From: Alison Leslie <alison@marleahleslie.com>
Sent time: 06/01/2020 03:46:01 PM
To: mindy.nguyen@lacity.org
Subject: Hollywood Center Project
Attachments: Hollywood Center Letter.pdf

RE: Public Comment--Hollywood Center Project Environmental Case: ENV-2018-2116-EIR
State Clearinghouse No.: 2018051002

Hollywood Center Project Environmental Case: ENV-2018-2116-EIR State Clearinghouse No.: 2018051002

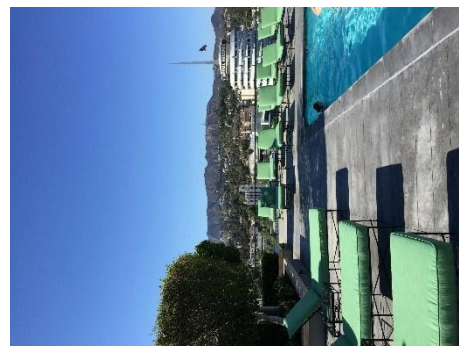
Specific Issue: The Broadway Hollywood Building Existing/Simulated Views:
EIR Figure View below is from grade point of view from Broadway Hollywood Building location looking north. There are additional visual impacts to review:

View looking south from the 101 freeway (a scenic highway) vine Exit 9A. The view of the Historic Building and Sign are iconic and a significant historic view is from the 101 freeway and at the exit elevation as one enters through the Hollywood gateway into the historic district and the iconic corner of Hollywood and Vine. The analysis shows existing/proposed views that are slightly east or west in the photos and do not capture the view of the Broadway Hollywood Building that exists. **This project will irreversibly reduce the importance of the Broadway Hollywood building and historic neon rooftop sign as an individual historic feature and as a contributor to the aesthetic character of the Hollywood Boulevard Commercial and Entertainment District. This meets potential aesthetics impact with a *Threshold (a) Would the Project substantially damage scenic resources, including but not limited to trees, rock outcroppings, and historic buildings within a City designated scenic highway?***

In addition to the building itself, the Broadway Hollywood Neon Rooftop sign is a historic sign that is a historic feature of the building and can be seen from the scenic highway. Blocking this vista requires specific compliance review under this EIR analysis and for impacts to the Broadway Hollywood Rooftop Neon Sign under the Hollywood Signage Supplemental Use District.

For context, and to capture the same line of sight from the opposite point of view from the top story of the Broadway Hollywood Building. **This project will directly impact and substantially block focal or panoramic views of and from this historic location.**

Figure 1: Bird's Eye view of only vehicle access point

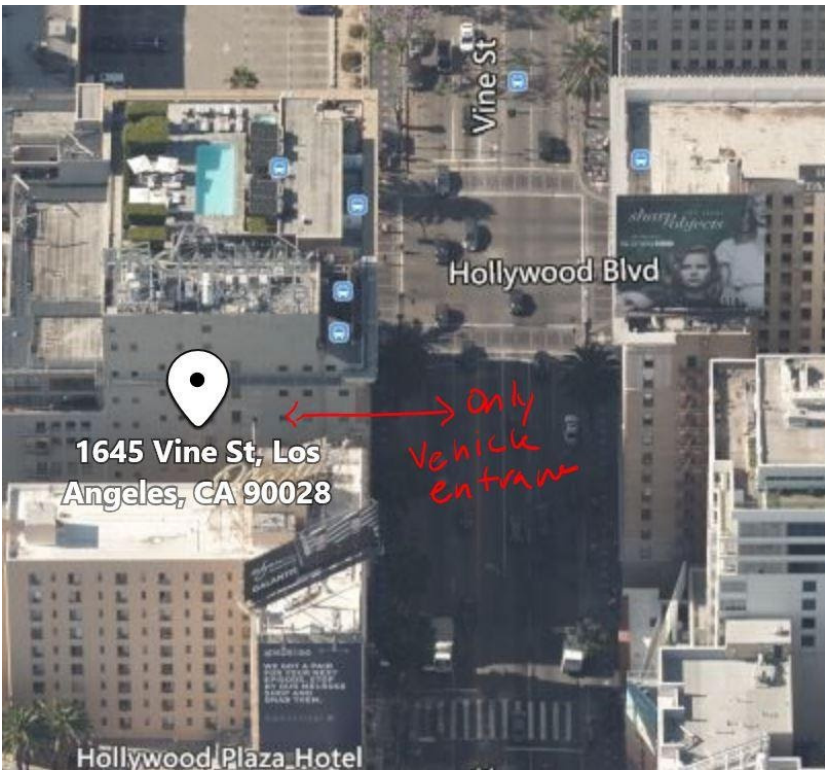
Specific Issue: Broadway Hollywood Ingress/Egress:

The N-2 LADOT Correspondence dated April 10, 2020, from the City Approving the Traffic study in the EIR, rates the intersection of Hollywood and Vine as an “F” during am/pm for 2027 projections. There is no Neighborhood Traffic Management Program analysis, nor project features, traffic signal analysis, or mitigation specifically address the significant impacts to unique to the Broadway Hollywood Building. The anticipated added traffic (vehicle and pedestrian) will create undue congestion and during operations and once the project is complete will significantly limit or restrict ingress and egress to the only vehicular entrance servicing the 96 live/work units. An updated impact analysis must be conducted to determine if the impacts of this project would pose life, safety, or a government taking of access (ingress/egress) to a private property of all individual (96) unit owners.

The only vehicle entrance for all building parking is located on vine through an alley between the building and the Hollywood Plaza building. Increased pedestrian or added traffic will block the only entrance to building parking. Taking access and/or increasing the burden of access to this building is a significant impact. There is no left turn into this alley, thus there is only one way access from Vine traveling south. Pedestrian flow impacts the ability for vehicles to enter or exit the alley onto the street.
